IRC - Building

2025 GROUP B PROPOSED CHANGES TO THE I-CODES

Committee Action Hearings (CAH #2)
October 22 - 30, 2025
Huntington Convention Center
Cleveland, OH

**APPENDIX BE
RADON CONTROL METHODS**

FIGURE BE101.1 EPA MAP OF RADON ZONES

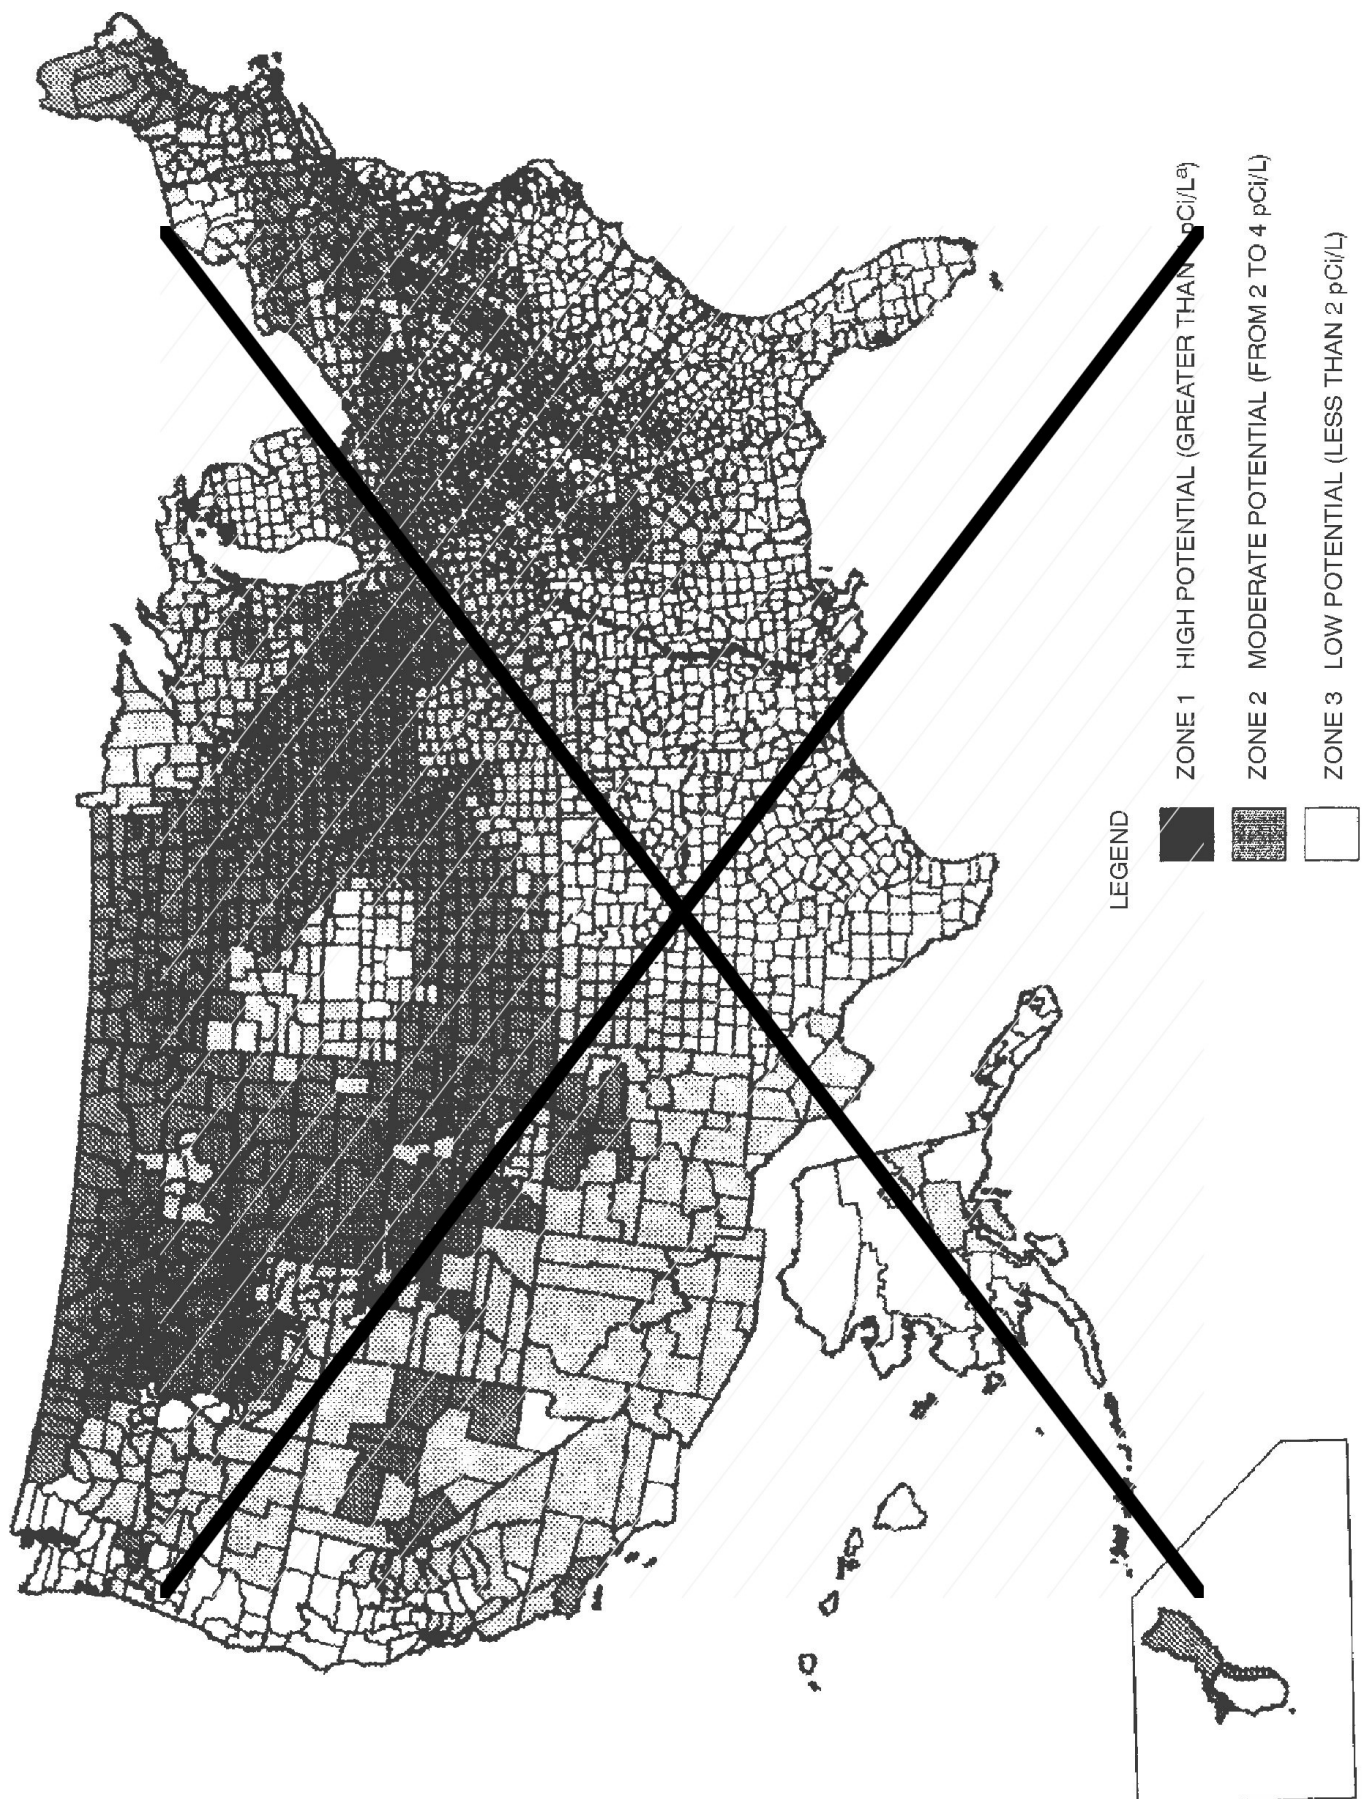
Delete without substitution:

The EPA and the US Geological Survey have evaluated the radon potential in the United States and have developed a map of radon zones designed to assist building officials in deciding whether radon resistant features are applicable in new construction.

The map assigns each of the 3,141 counties in the United States to one of three zones based on radon potential. Each zone designation reflects the average short term radon measurement that can be expected to be measured in a *building* without the implementation of radon control methods. The radon zone designation of highest priority is Zone 1. Table BE101.1 lists the Zone 1 counties illustrated on the map. More detailed information can be obtained from state specific booklets (EPA 401-R-93-021 through 070) available through the State Radon Offices or from the EPA Regional Offices.

The EPA map and Zone 1 county list are based in part on a 1993 survey that measured radon in 5694 homes, less than two per each of the 3141 counties in the US. As more recent data have been compiled by states and the US Centers for Disease Control and Prevention, it is evident that more counties' have homes that exceed the EPA action level.

Radon Zone 1 counties are defined as having a predicted year-round average indoor radon screening level in the lowest livable area of a structure greater than or equal to four picocuries per liter of air (pCi/L). Relying on an average radon level does not address the full range of risk within a given county. Levels greater than 4 have been found in 85% of US counties tested.

The purpose of the EPA radon zone map, since its inception, has been to show potential of risk not ACTUAL risk. While it is still a useful tool, the map unintentionally creates a false sense of security for those in Zone 2 and Zone 3 that risk in those areas is non-existent. The fact remains that radon is found in all zones and to truly protect against radon you need to test regardless of zone.

Committee Reason: This proposal was disapproved. The committee agreed with the deletion of the maps. A jurisdiction should decide if a radon control method is required. However, the committee attempted to make modifications to revise the language in RE101.1 and ended up with conflicting modifications. Rather than continue to work on this question, the committee request the proponent to come back in CAH2. (Vote: 9-1)

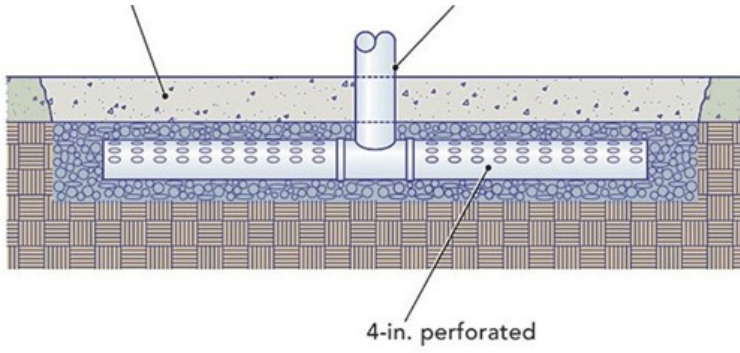
This proposal provides a soil gas collector and keeps open the horizontal openings in the tee fitting for both sub-slab and sub-membrane (crawl space) installations. The tee fitting is a suction point through which radon gas is pulled from below the building into the vertical vent pipe. If no pipe is present to protect the side openings in the tee fitting from filling with concrete (when the slab is cast) or aggregate, the above ground pipe cannot vent radon from below the structure to the outside.

Attaching five foot long perforated piping to tee fittings is required by the USEPA recommended CCAH 2020 Rev 5/23 for both sub-slab and sub-membrane systems.

Committee Reason: The proposal was disapproved. The pipe comes in 10 foot pieces. A 5 foot length is a random choice, that would require the 10 foot pipe to be cut exactly in half. Allowing a length such as 4 feet minimum would improve compliance options. There were questions about how the Geotech mat would be installed 'connected' to the horizontal opening. (Vote: 6-4)

The committee was supportive of the concept but disapproved the proposal under the theory that an inexact half cut of a 10' pipe would cause a code violation for the shorter length. The public comment proposes requiring installation of a minimum of 4.5' perforated pipe on each side of the tee fitting to avoid this.

There were questions about how the geotextile mat would be installed or connected to the horizontal opening. These connections are made using fittings provided by the geotextile mat manufacturer.
